Notice of Modification

Section 75W of the *Environmental Planning and Assessment Act 1979*

Project Approval 05_0117 for the Moolarben Coal Project Stage 1, granted by the Minister for Planning on 6 September 2007.

Figure 2.1 – General Overview and property ownership

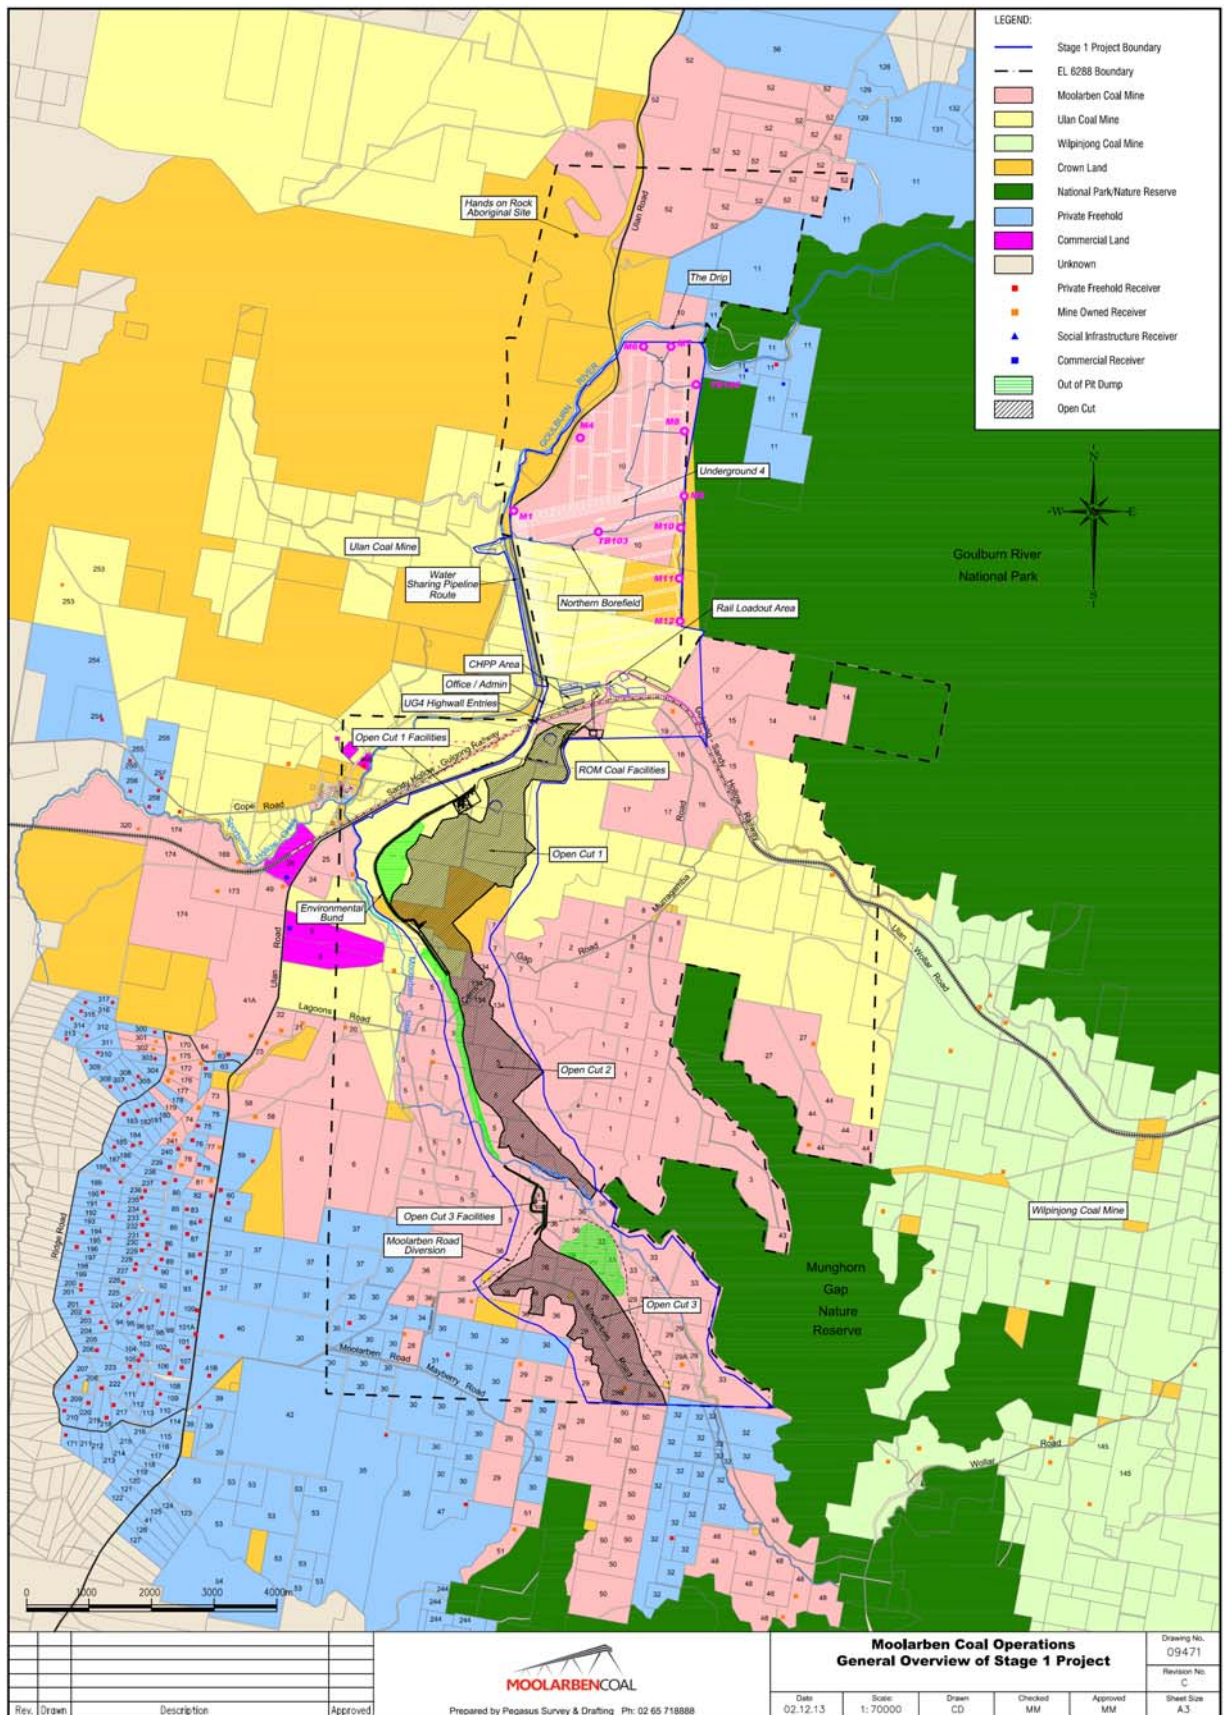
44. In Appendix 2 replace all figures with the following:

Figure 7.1 Sensitive Natural Features

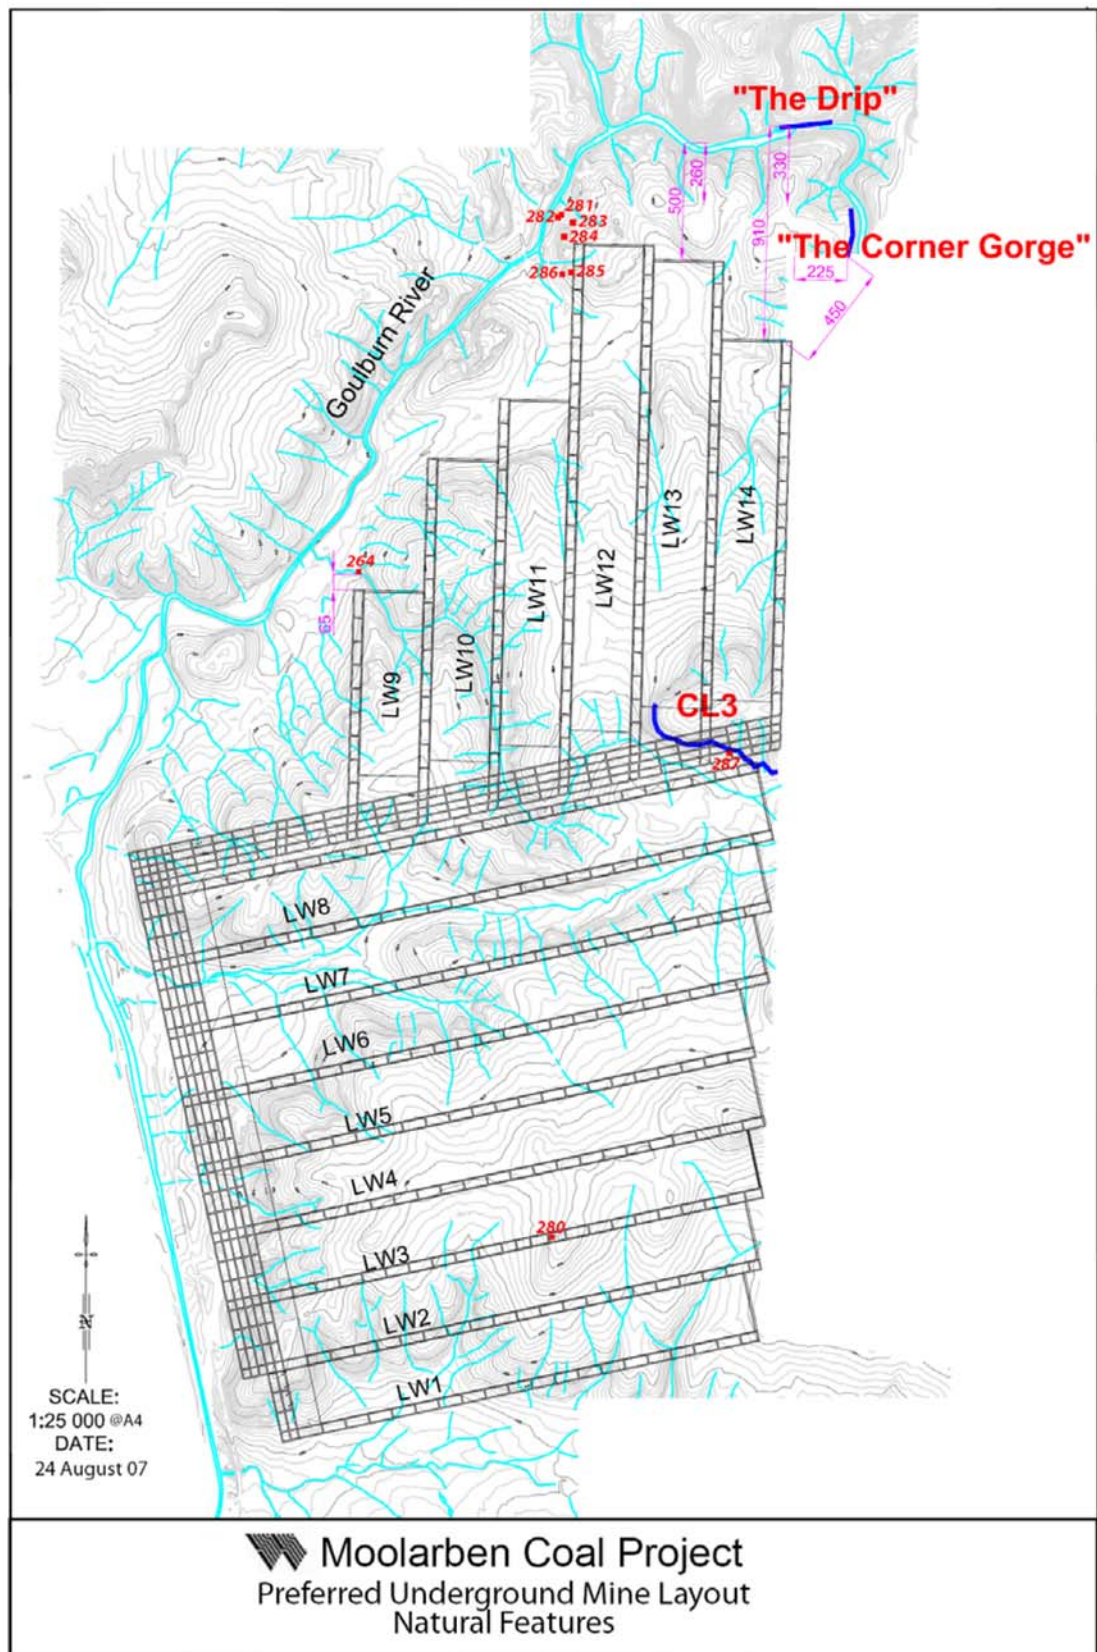
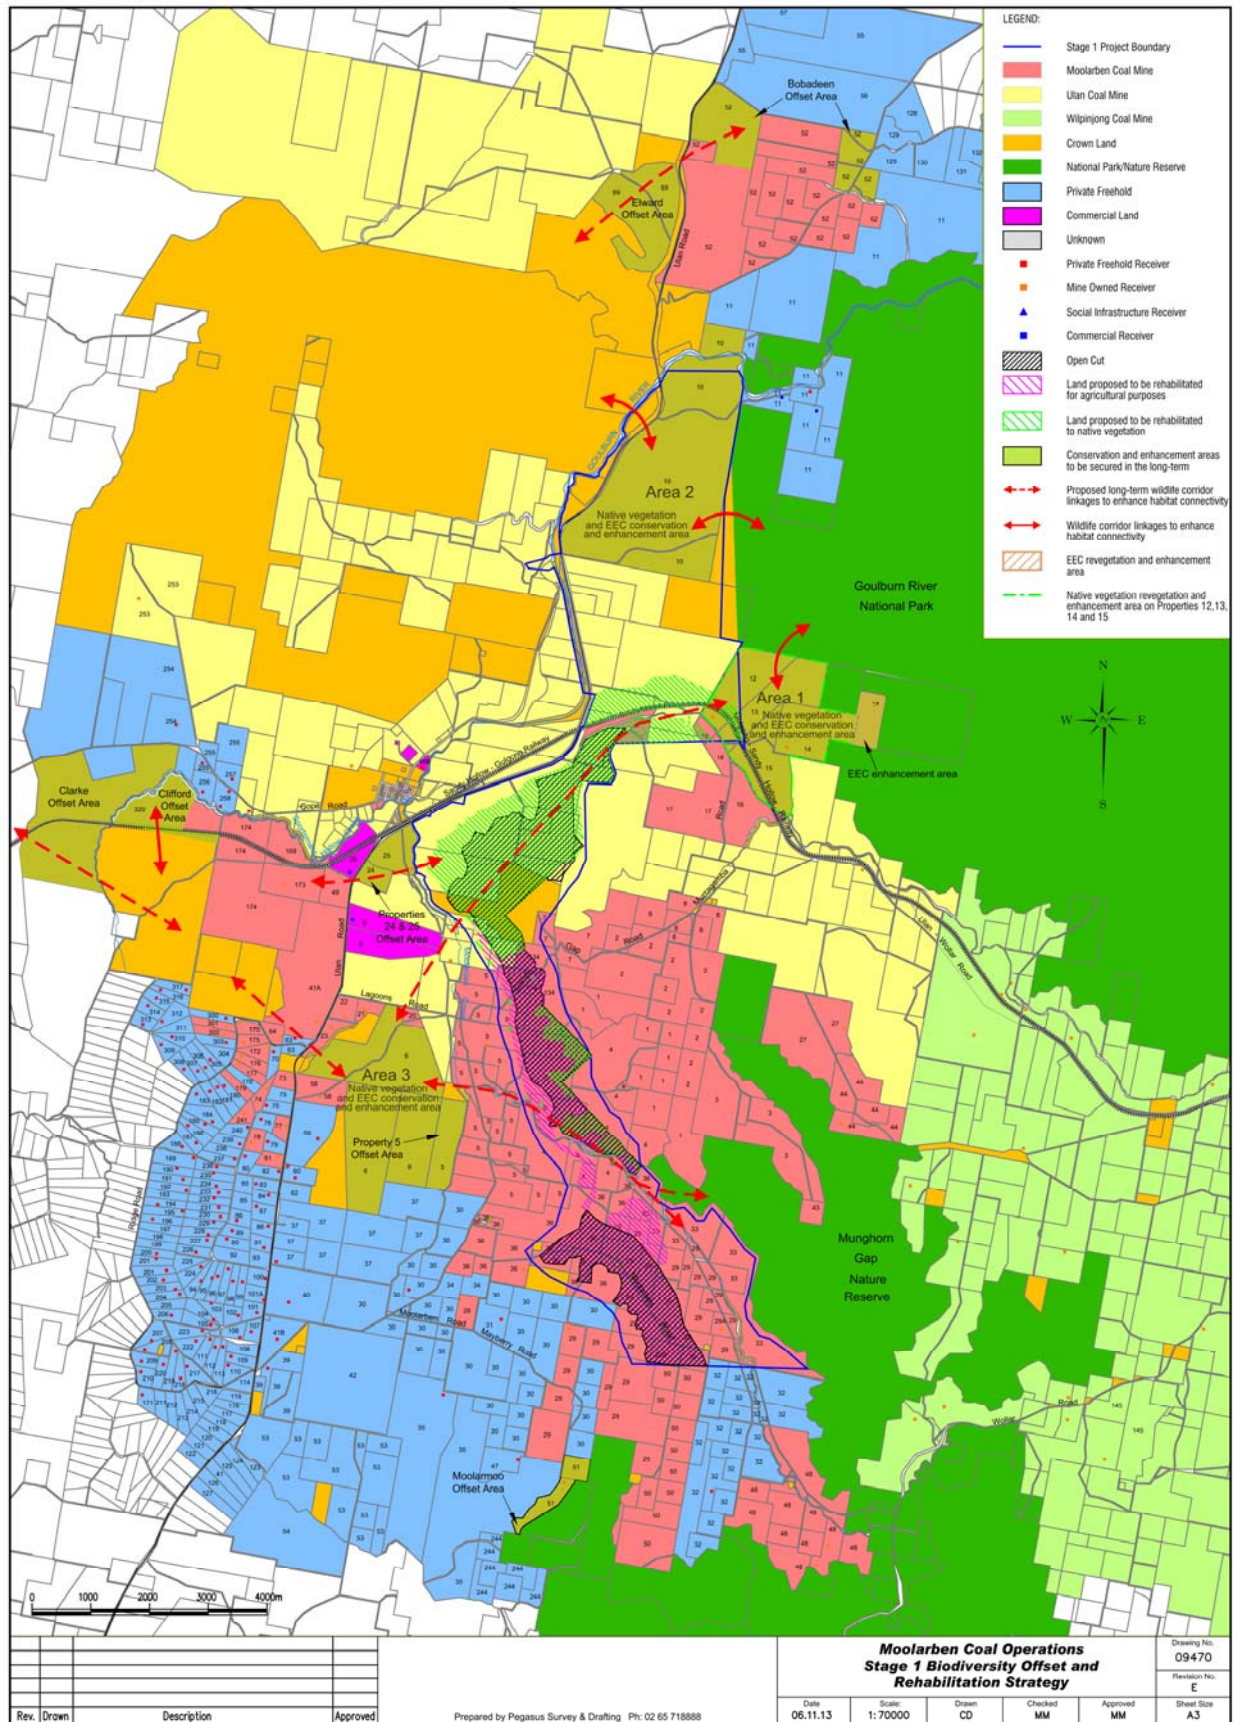
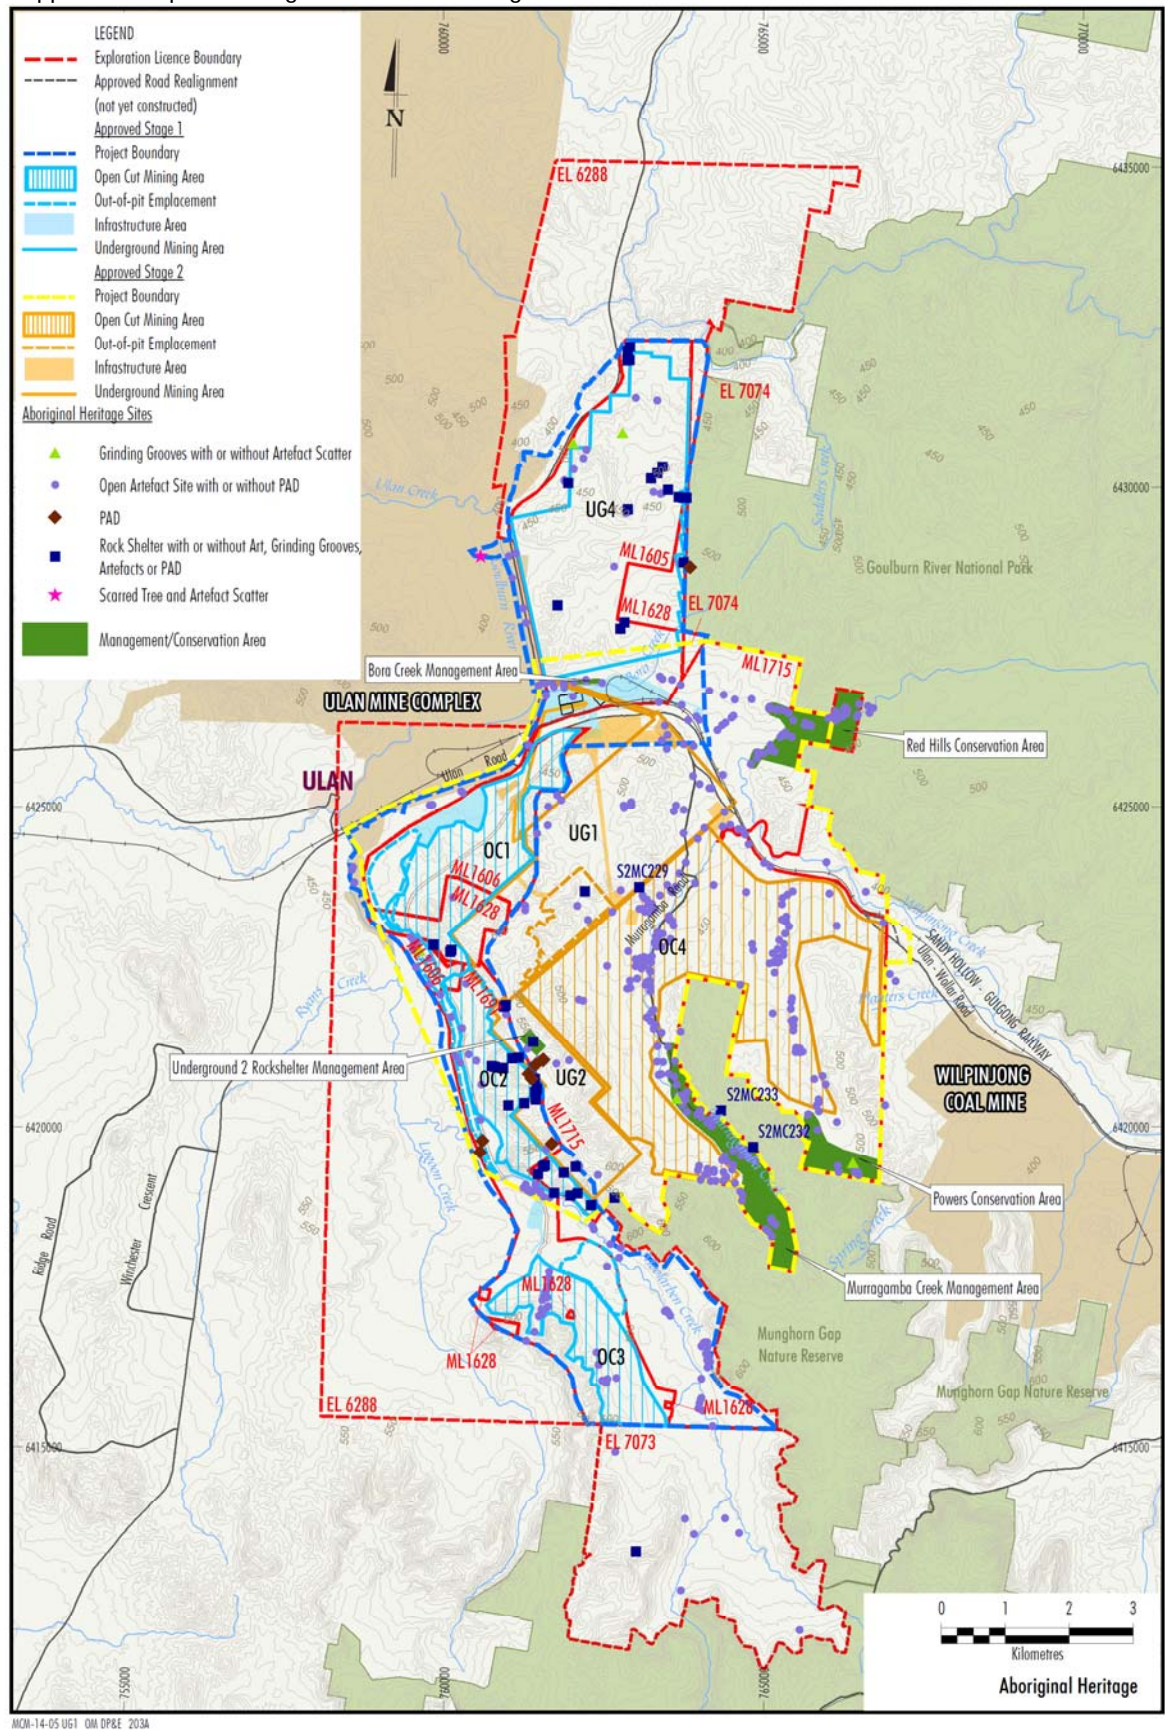
5A. The Proponent shall ensure longwall mining of panels LW9 to LW14 (as marked in figure 7.1 of Appendix 7):

- (a) does not commence until LW1-LW8 have been completed; and
- (b) progresses in the sequence numbered, i.e. panel LW9 is to be completed first and panel LW14 is to be completed last.

Note: The locations of LW9-LW14 are marked in Appendix 7, figure 7.1.

45. In Appendix 7 insert the following:
